DEPARTMENT OF THE AIR FORCE
HEADQUARTERS 377TH AIR BASE WING (AFMC)

**Subject: Soil Vapor Extraction Well Design, Location, and Installation
Interim Measures Work Plan, Bulk Fuels Facility Spill, Solid Waste Management
Units ST-106 and SS-111
Addendum November 2011
Albuquerque, New Mexico**

FIGURE 1
 LAB TOTAL VAPOR VOC PLUME
 FOOTPRINTS BY ELEVATION
 JUNE 2011

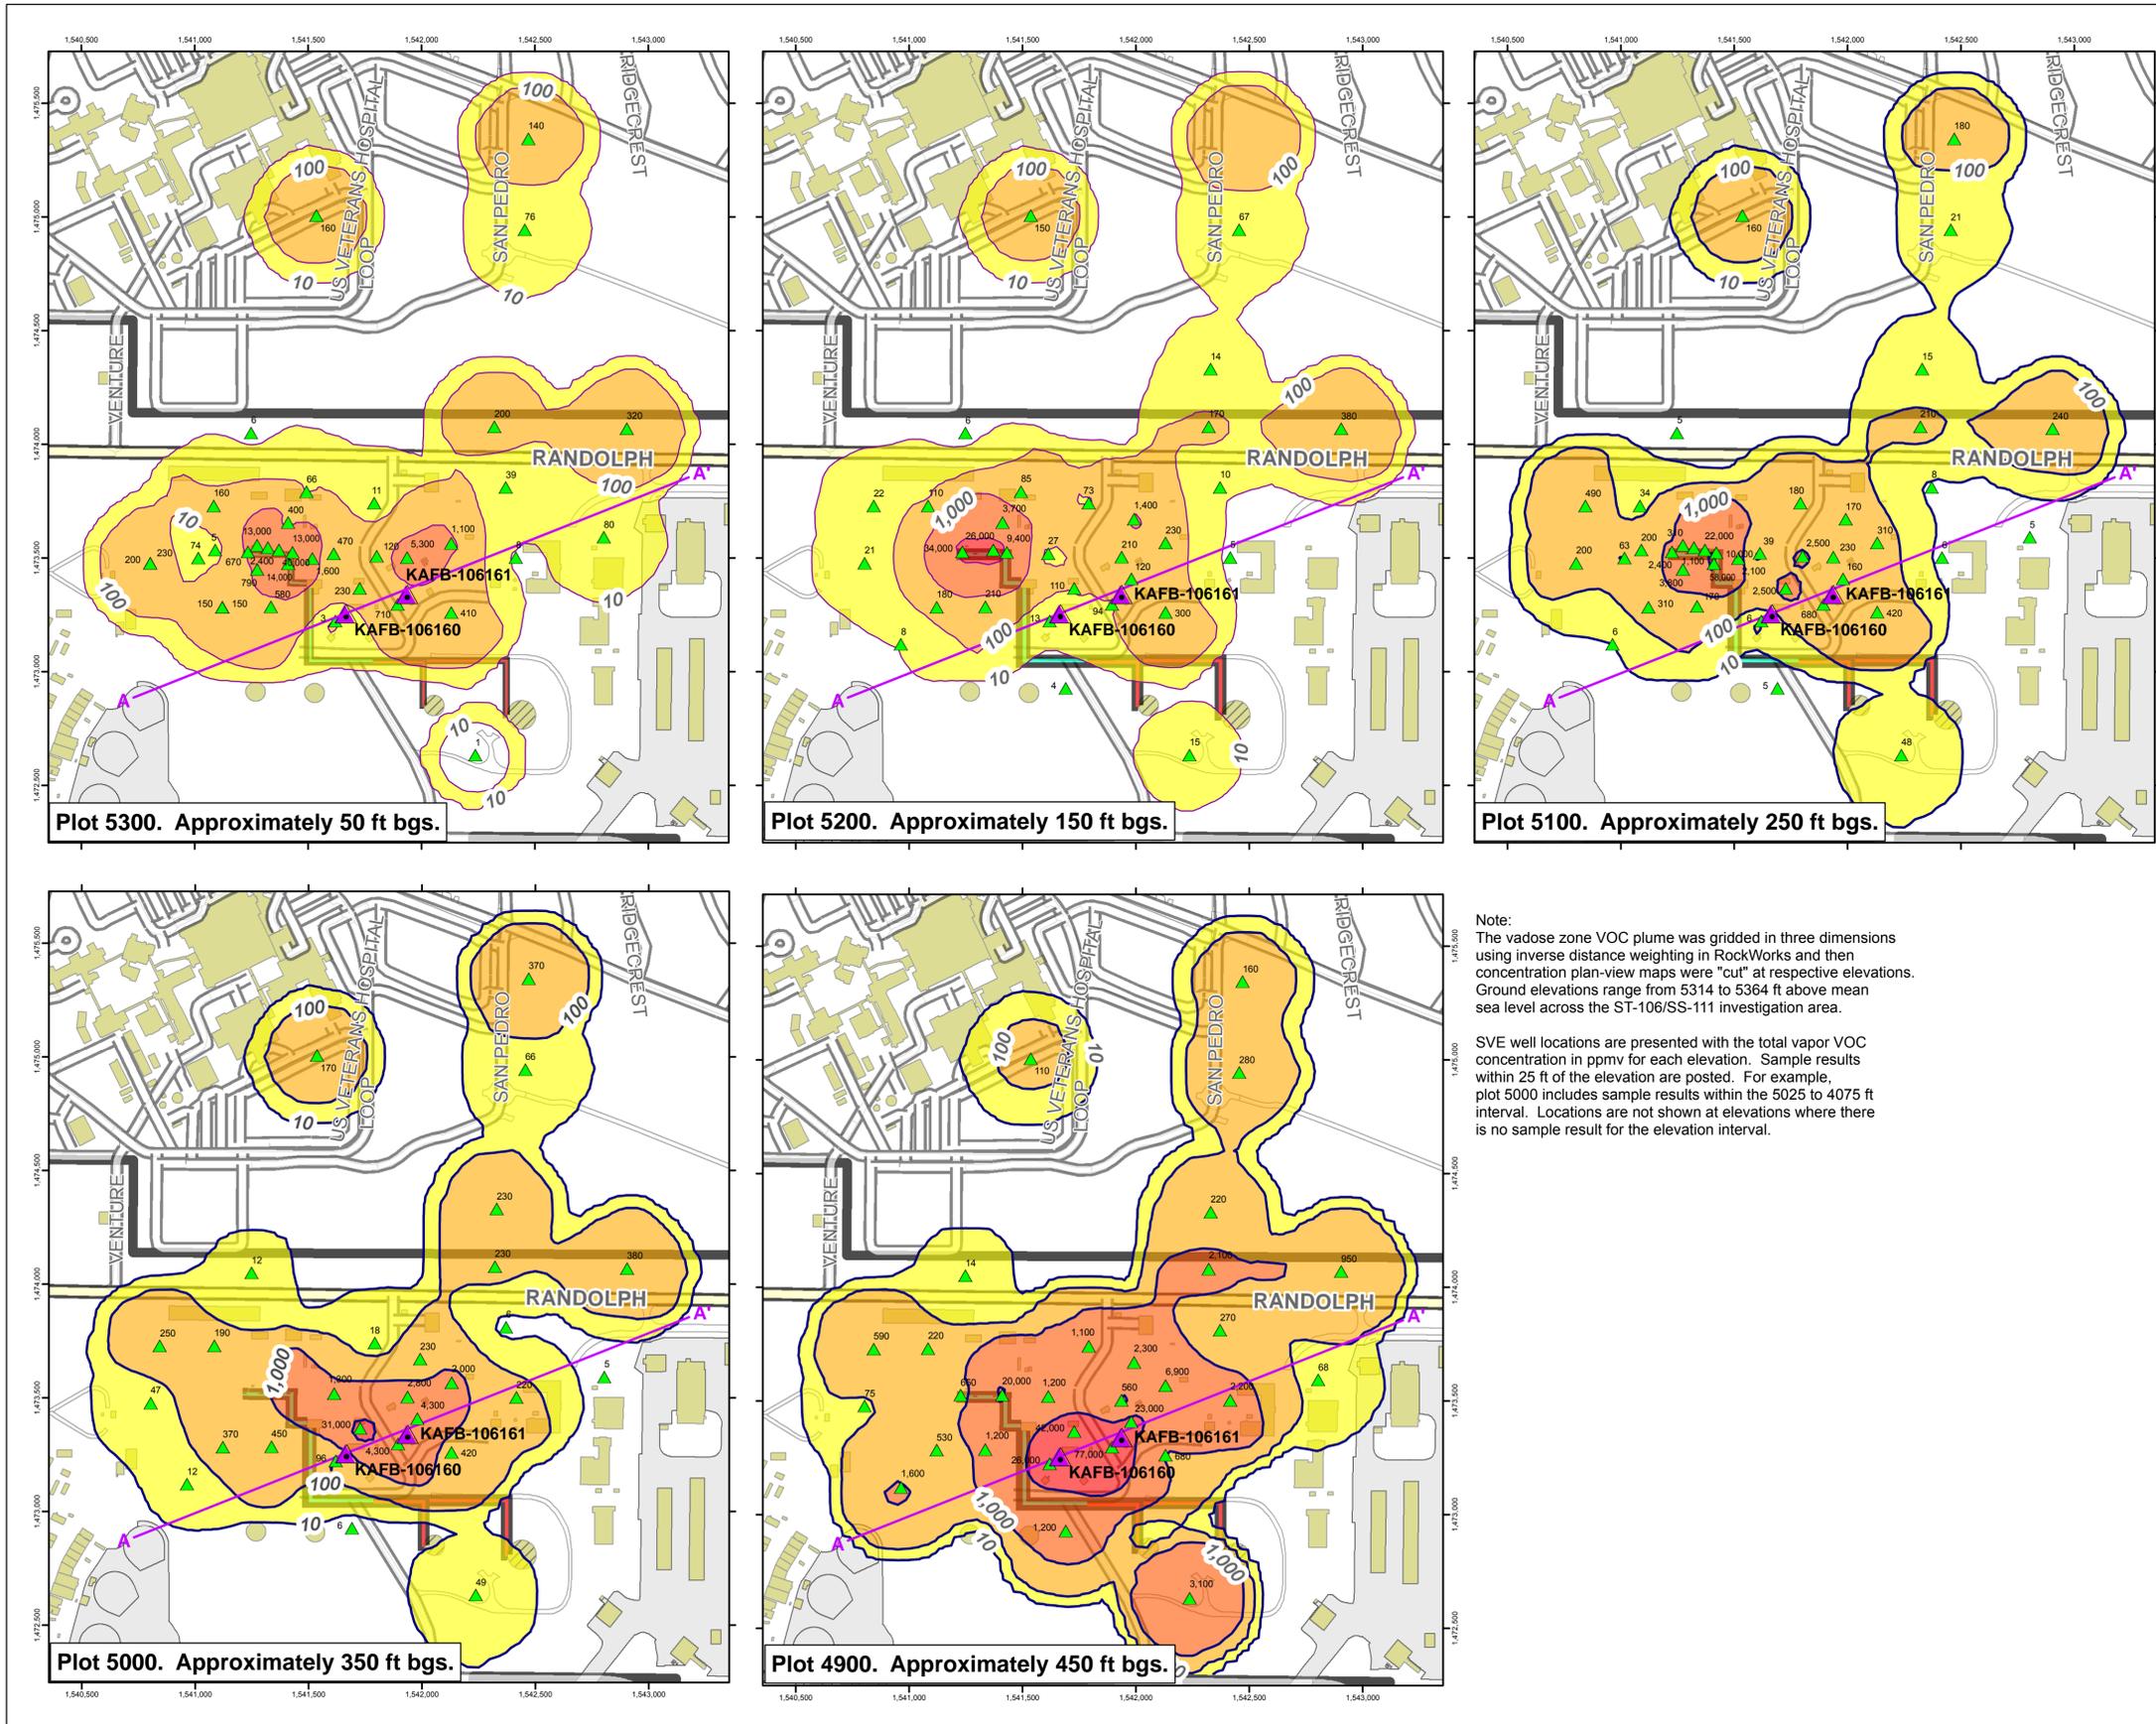
Figure 1, attached to this letter, shows the proposed locations of the two SVE wells, KAFB-106160 and KAFB-106161. Both wells are located on the installation and are within the region showing the highest concentration of vapor based on the results of Quarter 2 (April – June) 2011 data (Figure 1). The spacing of the wells is based on the vapor results, as well as a preliminary understanding of the radius of influence for soil vapor extraction units screened in the vadose zone.
